STAFF REPORT
CITY OF LAKE OSWEGO

LU 13-0043

17150 Boones Ferry Road

- A Development Review Permit to construct a 1,057 sq. ft. Goodwill Donation Center and a 6,416 sq. ft. retail commercial building;
- Two Minor Variances: 2-foot reductions to the 20-foot front and street side yards setbacks;
- A Hardship Variance to allow a direct access point onto Boones Ferry Road (an arterial street); and,
- The removal of seven trees to accommodate the proposed development.

Siding

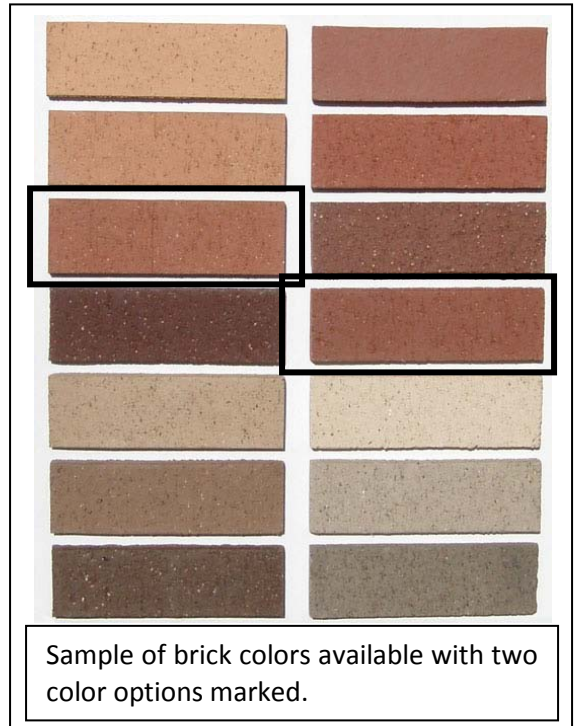
The applicant proposes to clad both buildings primarily in CMU ground face block veneer (Exhibits E14-E15 and F1-F2). There are two different sizes and colors of CMU (Exhibit E25). A 3.5-foot tall base of natural grey CMU block veneer, eight inches high and 16 inches long, is proposed on both buildings. Above that base, the applicant is proposing a sandstone CMU block veneer that is four inches high and 16 inches long. On the retail building, the applicant is proposing large areas of horizontal lap wood composite siding with 4-inch exposure (Exhibit E15). Proposed secondary siding on the retail building is composite stucco (Exhibits E15 and E25). Secondary material on the donation center is small mosaic areas of primarily blue tile (Exhibit E14 and E25).

Staff finds that the horizontal lap wood composite siding is consistent with and complementary to the horizontal siding material of the Lake Grove Vet Clinic. The proposed 8x16 inch natural grey CMU block veneer base on both buildings is also consistent with and complementary to the base of the Crossing office building. The use of the tile mosaics on the donation center’s Boones Ferry Road façade is proposed to provide visual interest and is a part of the Goodwill corporate image. Staff finds that the mosaic areas provide an accent detail that is unique to the building without overwhelming the overall design.

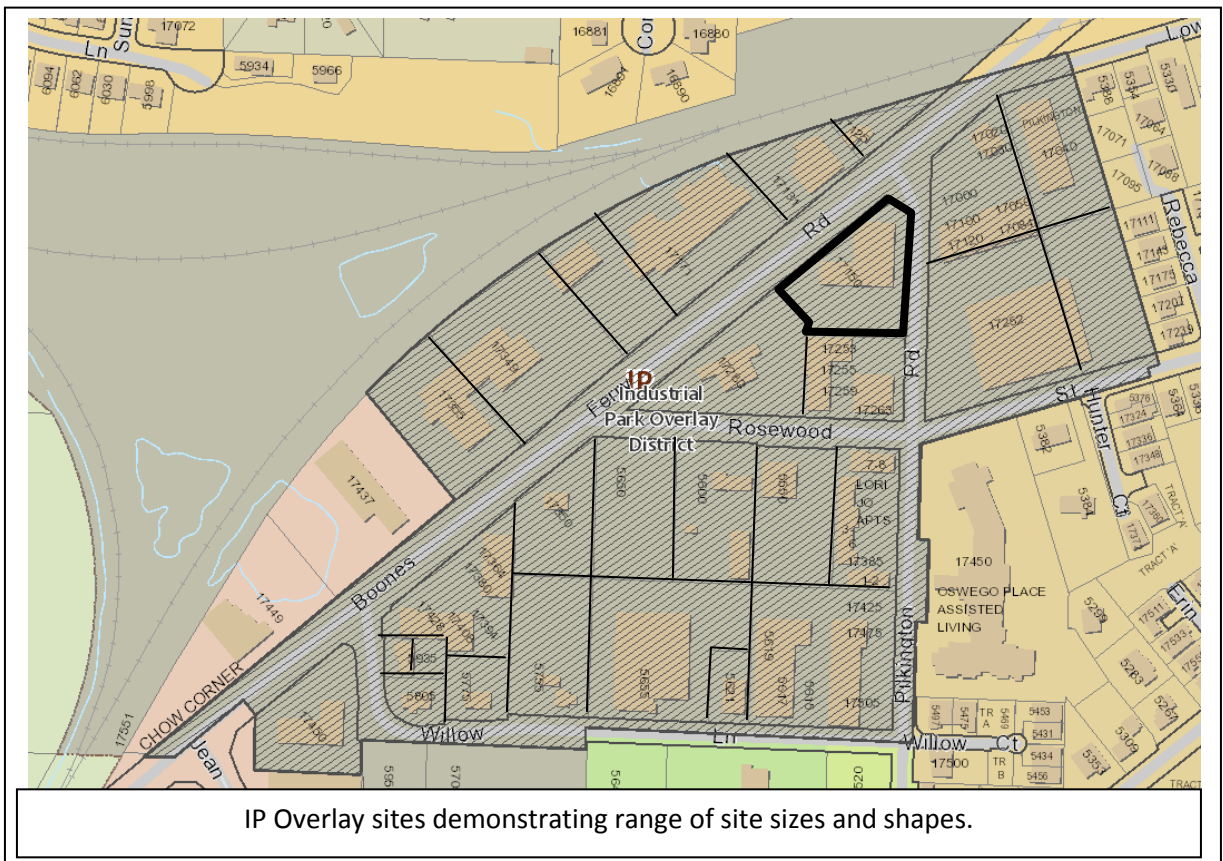
The applicant is requesting a Hardship Variance to allow direct access off of Boones Ferry Road (a major arterial), which is not permitted by Access standards (LOC 50.06.003.1.c.iii) (Exhibits E5 and F3-F4). The proposed 13-foot wide driveway will provide access to this site and incorporates a shared 13-foot access easement on the abutting property to the west that widens the driveway approach to 26 feet to ensure adequate width for truck turning movement (Exhibit E3). Final build-out width of the proposed access is proposed to be a 26-foot shared driveway partially located on the abutting property when that site redevelops (Exhibits E5, F3-F4, and F10).

The Code provides the granting authority a number of factors in determining whether hardship exists. This is not an exclusive listing of factors and not all factors must be found to exist on the property in order to meet the “prevent an unnecessary hardship” criterion. One must first determine whether there is a hardship resulting on the property before determining that the hardship is unnecessary. Staff will start the analysis at this point.

Staff recommends that the Commission deny the Hardship Variance and provide the applicant the opportunity to submit revised site plans for review that fully comply with Access standards.

Public Pathway Lighting

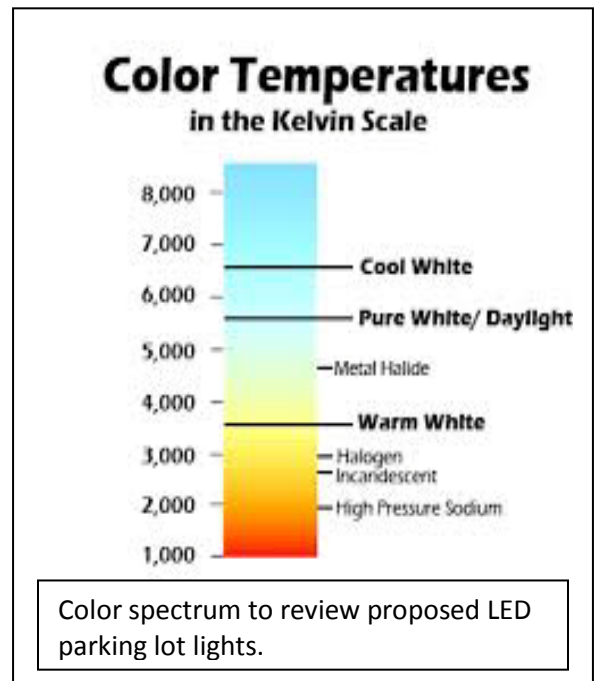
Per LOC 50.06.004.3.b.i, public sidewalk lighting shall be low level lighting *of less than* 0.3 average foot-candles and with a maximum uniformity of illuminating ratio not to exceed 20:1. The applicant’s narrative states that the proposed lighting for the public pathways will be *a minimum of* 0.3 foot-candles and does not discuss the maximum uniformity ratio (Exhibits E19 and F1)). As a condition of approval, staff recommends that the applicant provide a revised photometric plan that demonstrates full compliance with public sidewalk lighting standards.

- f. The Pilkington Road driveway approach shall be a maximum of 24 feet, to the satisfaction of the City Engineer.
2. Provide a revised photometric plan that demonstrates compliance with public sidewalk lighting standards, including average lighting of less than 0.3 foot-candles and a maximum uniformity ration of 20:1.
